Regional Municipality of Durham

Bid Opportunity: T-1032-2021 – Relocation of Oral Health Clinic to 200 John Street, Oshawa

Addendum Number 01 - April 29, 2021

DEMOLITION REFLECTED CEILING PLAN FACILITY CODE FACILITIES PROJECT NO. PROPERTY NO. LEA-0-07 LEA-0-07-19-0 CONTRACT NO. DRAWING NO. SHEET NO.

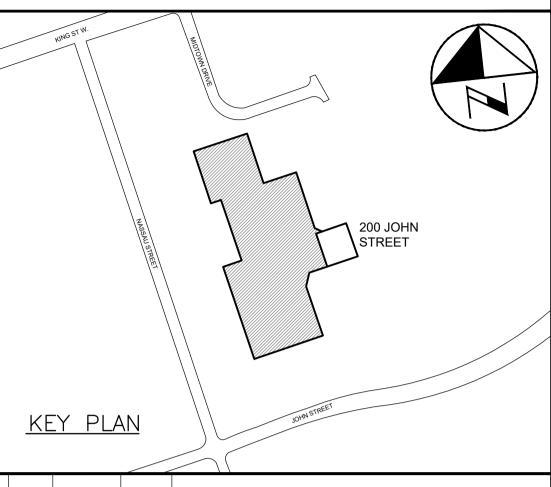
- .1 Drawing A-004 Demolition Reflected Ceiling Plan has been modified as part of this addendum.
 - .1 Noting demolition on existing access hatches in washrooms.

GROUND FLOOR PLAN A005

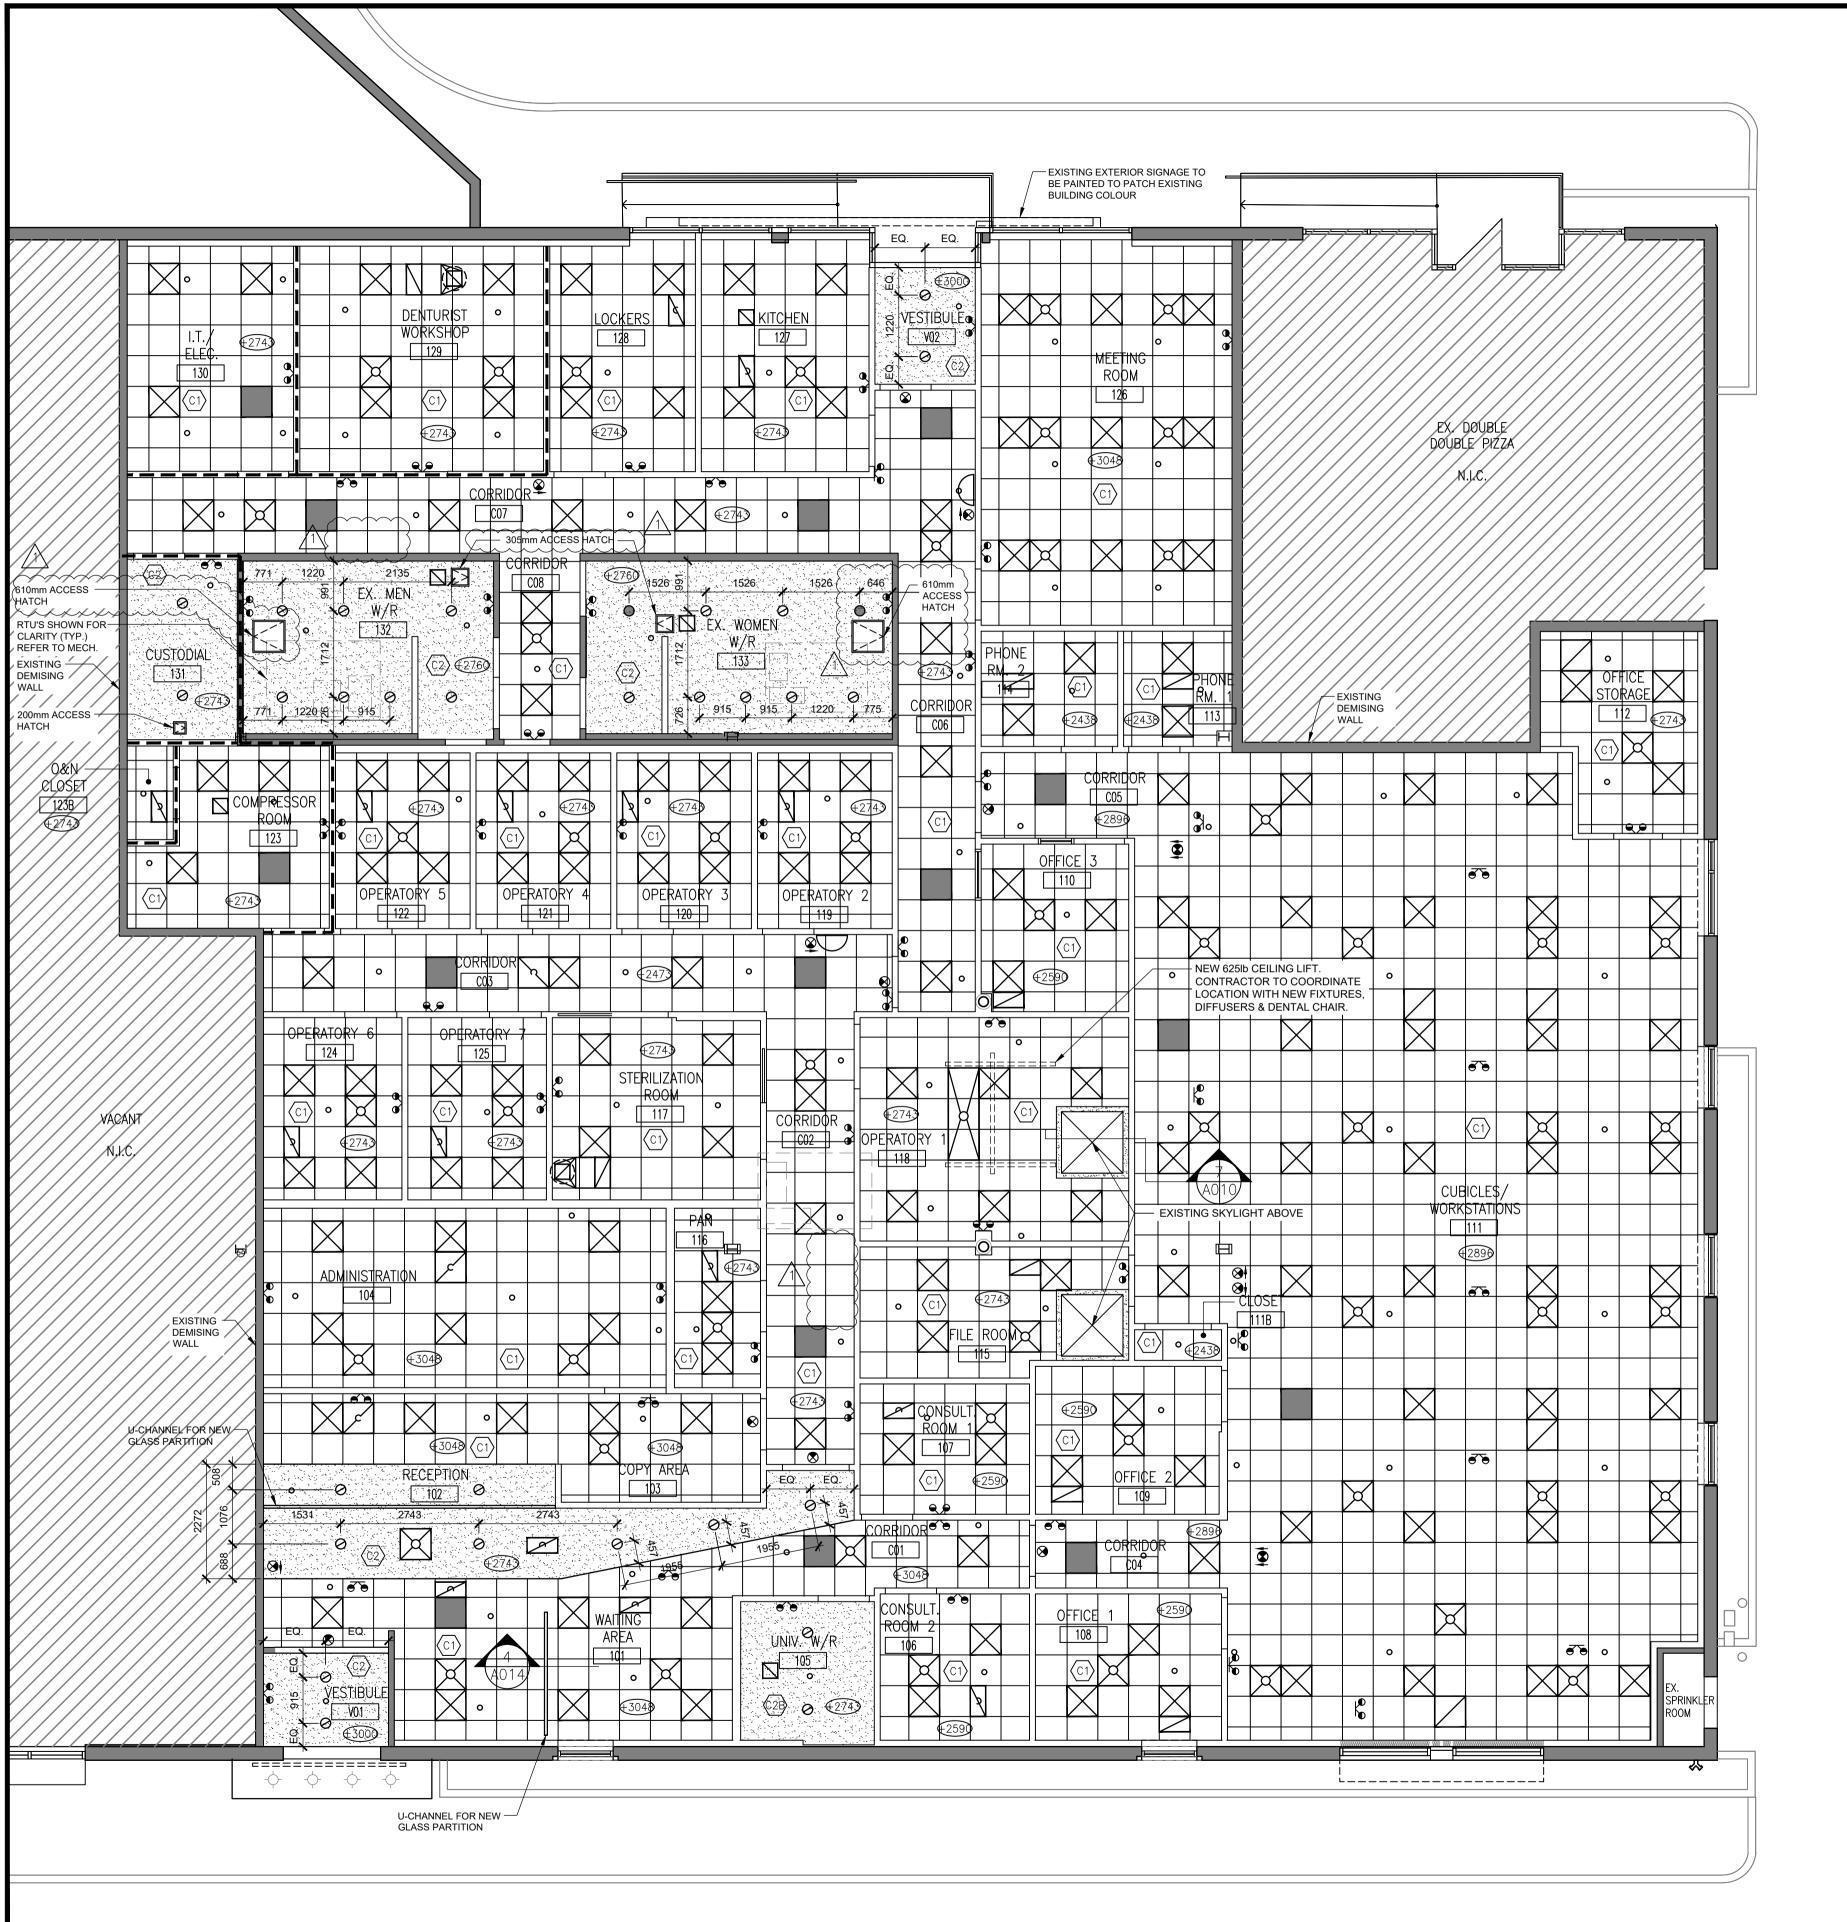
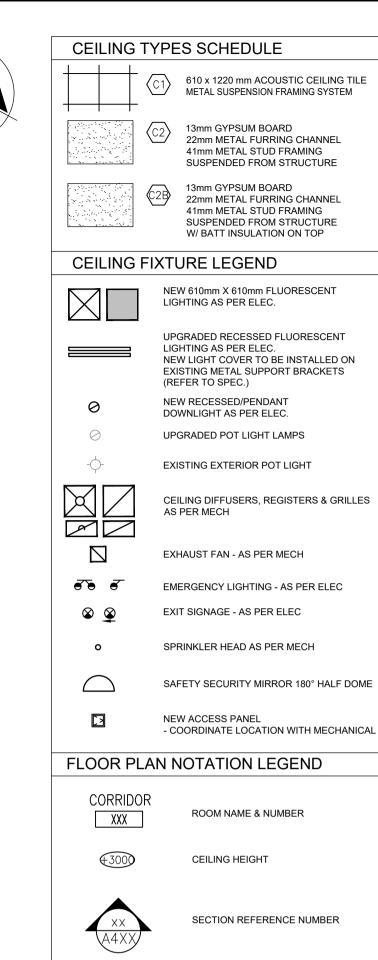
- .2 Drawing A-005 Ground Floor Plan has been modified as part of this addendum.
 - .1 Door 111B was shifted to the west.
 - .2 Reception 102 millwork has been slightly revised. Also refer to revised Drawing A-014 Millwork Details.
- .3 Drawing A-006 Reflected Ceiling Plan has been modified as part of this addendum.
 - .1 Relocated location of new access hatches in washrooms.
 - .2 610 mm x 2440mm ceiling tiles for filter access have been removed.
 - .3 Ceiling heights have been adjusted.
- .4 Drawing A-014 Millwork Details has been modified as part of this addendum.
 - .1 Removed deal trays from drawing and provided cut out in glazing.

Yes, the mailbox specified is the outdoor drop box to the right of door V02A on drawing A-005.

REFLECTED CEILING PLAN

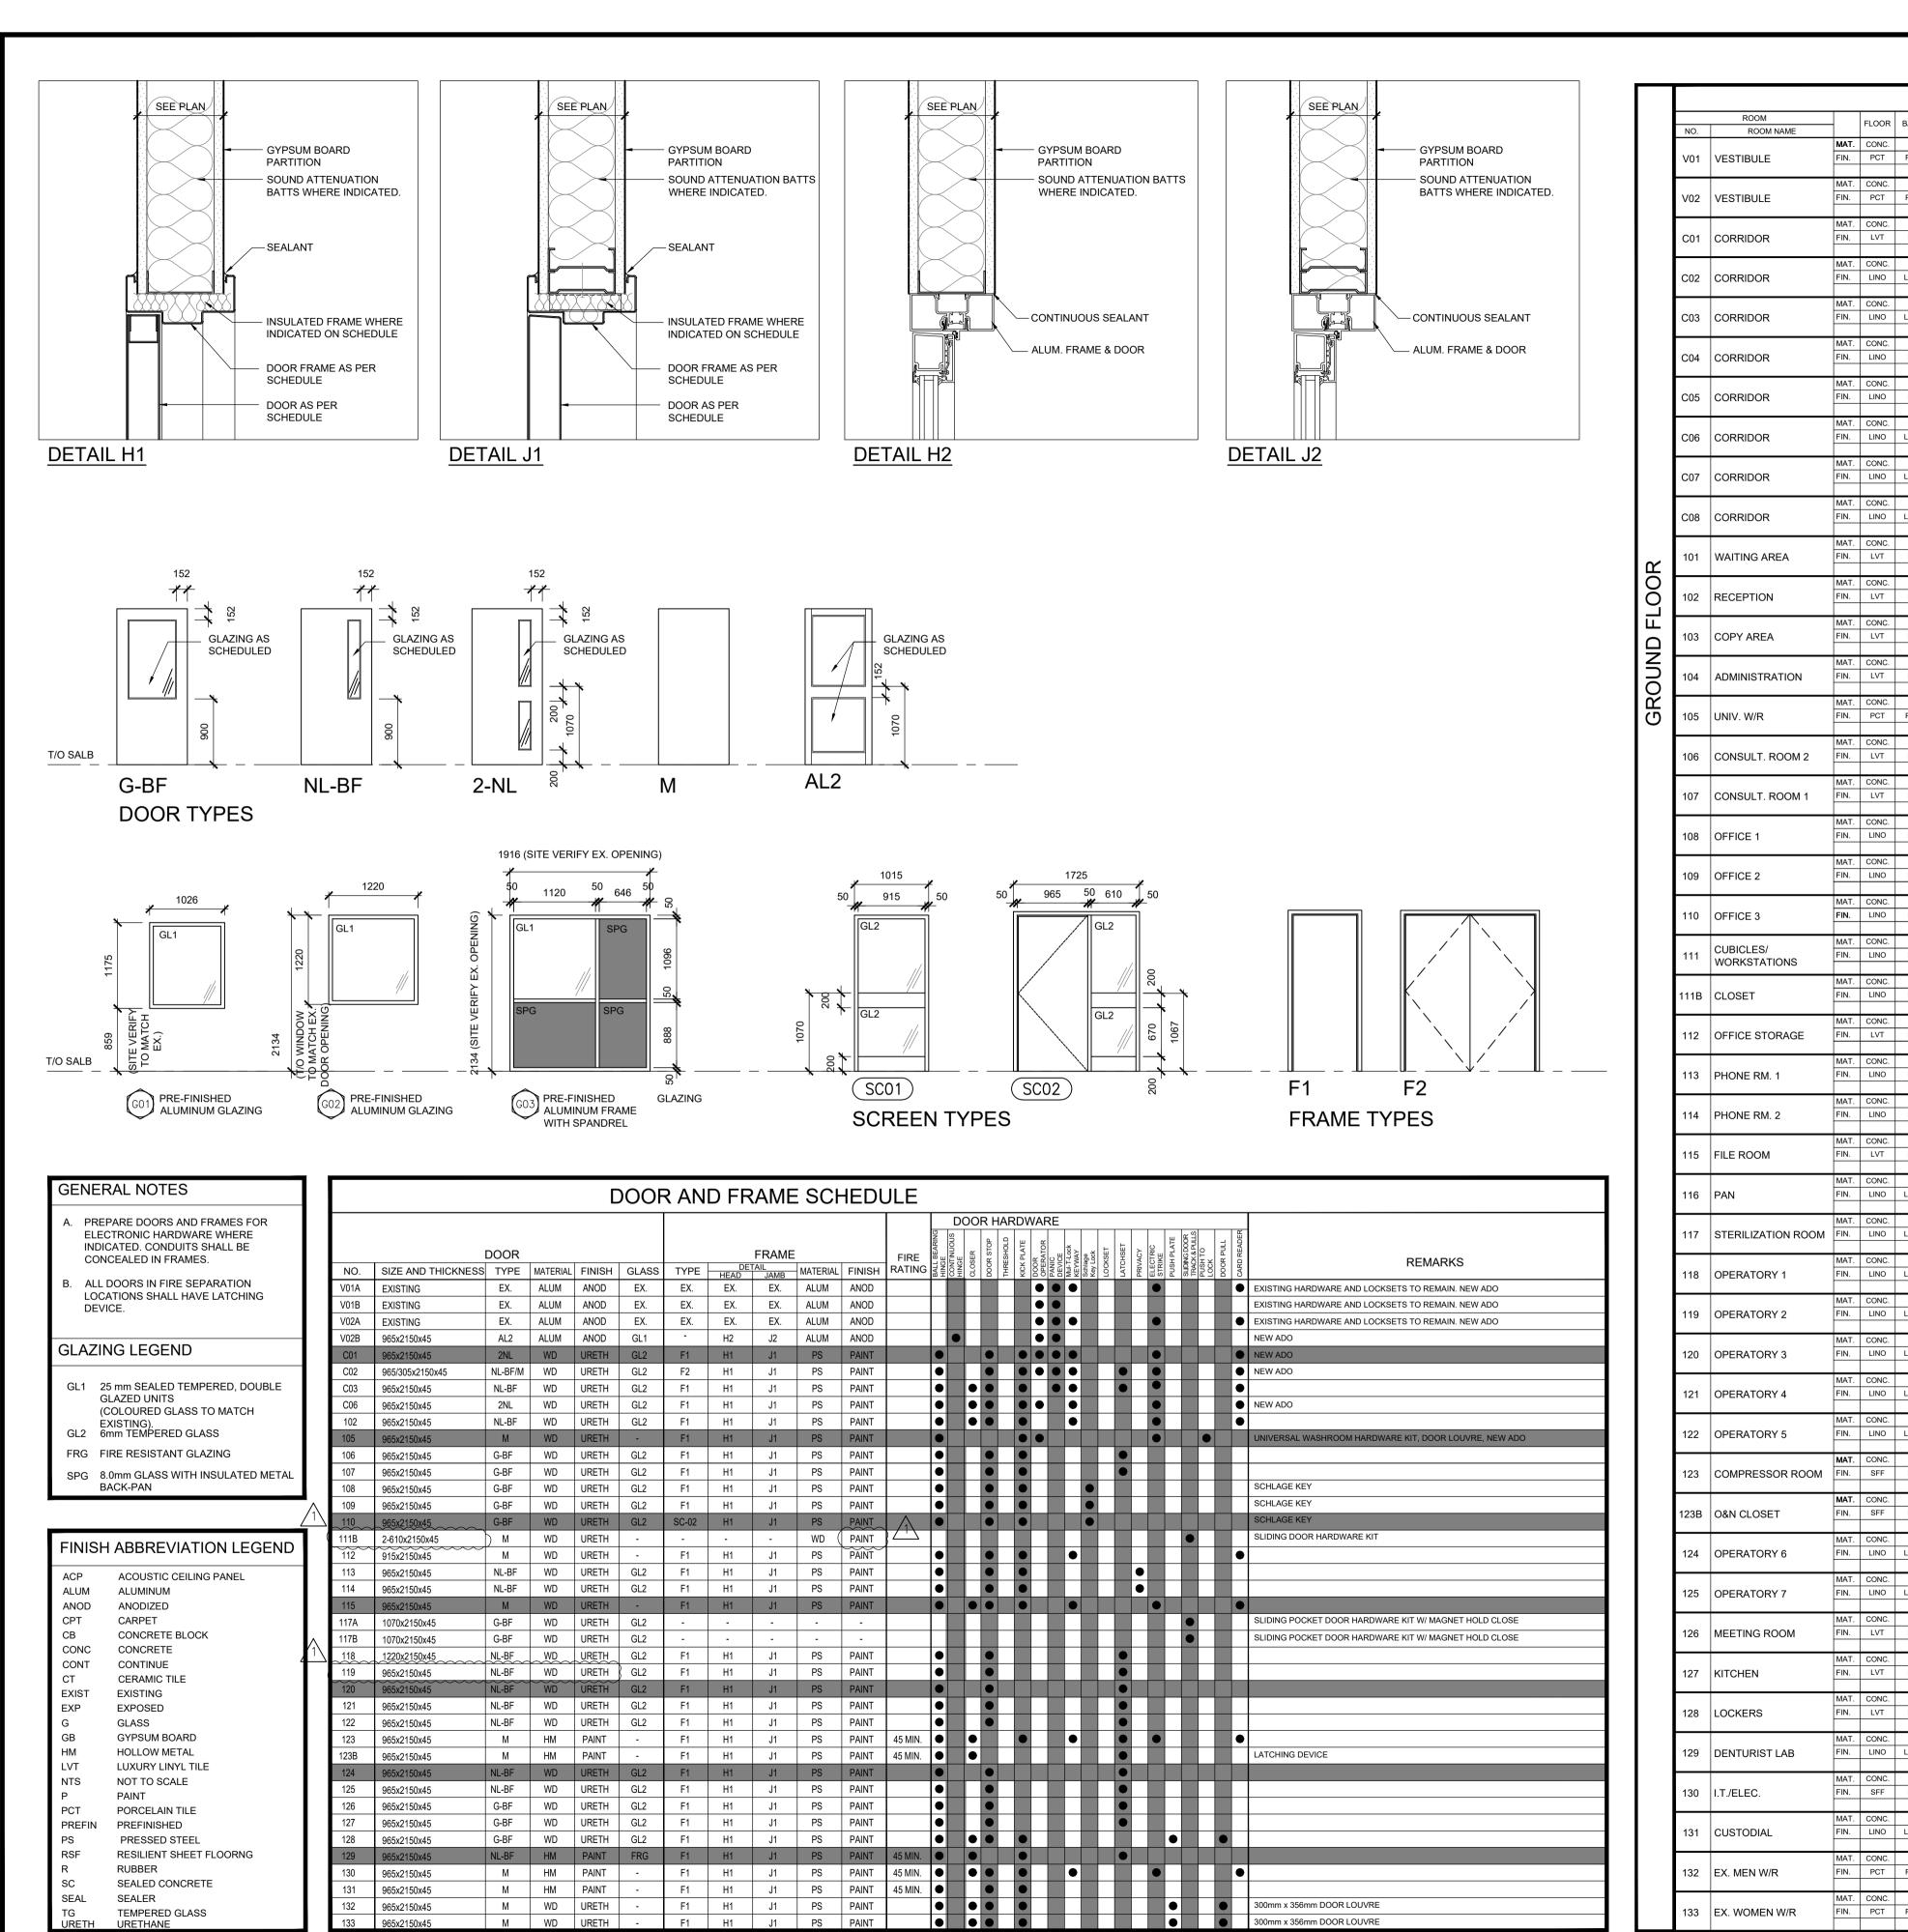
Refer to details 1-3/A-014.
 - .2 Noted locations and quantity of speak-thru's required. Refer to details 2&3/A-014.
 - .3 Extra reception chair included.
- .5 Drawing A-017 Schedules has been modified as part of this addendum.
 - .1 See clouded revisions on door schedule to reflect questions throughout Addendum 01.
 - .2 Ceiling heights have been adjusted.
